PRODUCT ADVISORY

Data Sheet Specification Correction for the Listed Intersil ISL4260* QFN Packaged Products

**Refer to:
PA10066**

Products Affected: **ISL4260EIRZ ISL4260EIRZ-T**

Incorrect POD – PA10066

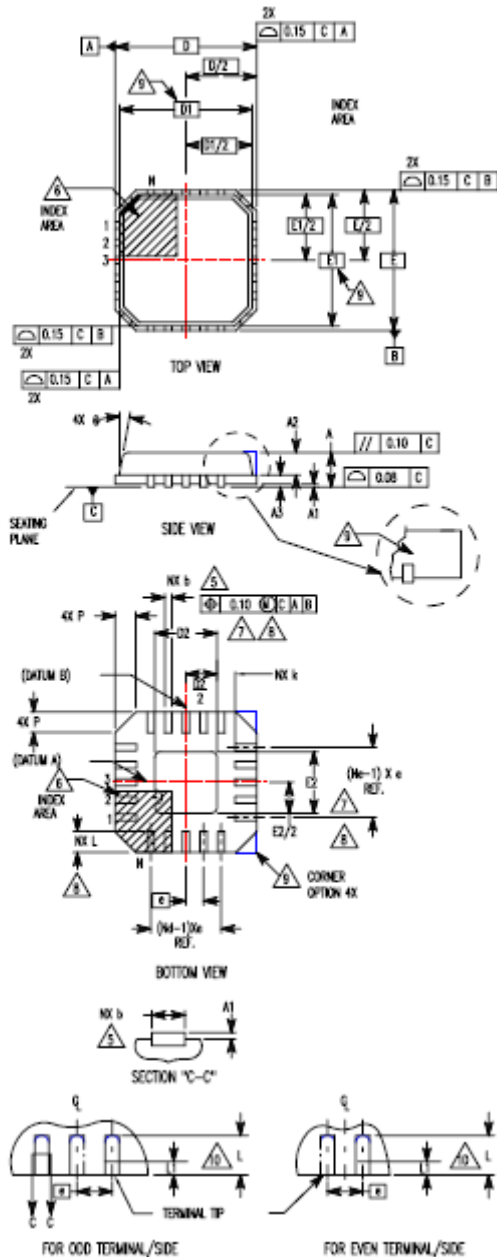
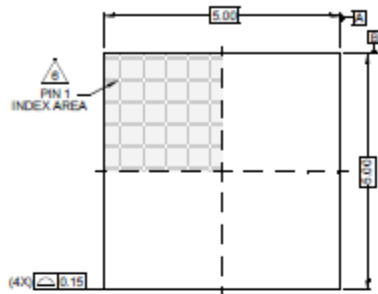
This advisory is to inform you that Intersil has made corrections to the POD (Package Outline Drawing) referenced in the data sheet specification for the listed Intersil ISL4260* QFN (Quad Flat No-Lead) packaged products. The updates to the POD correct the exposed pad dimensions and incorporate Intersil's new POD format. There have been no changes made to the package or product itself. The updated data sheet incorporating the corrected POD is available on the Intersil web site at <http://www.intersil.com/data/fn/fn6035.pdf>.
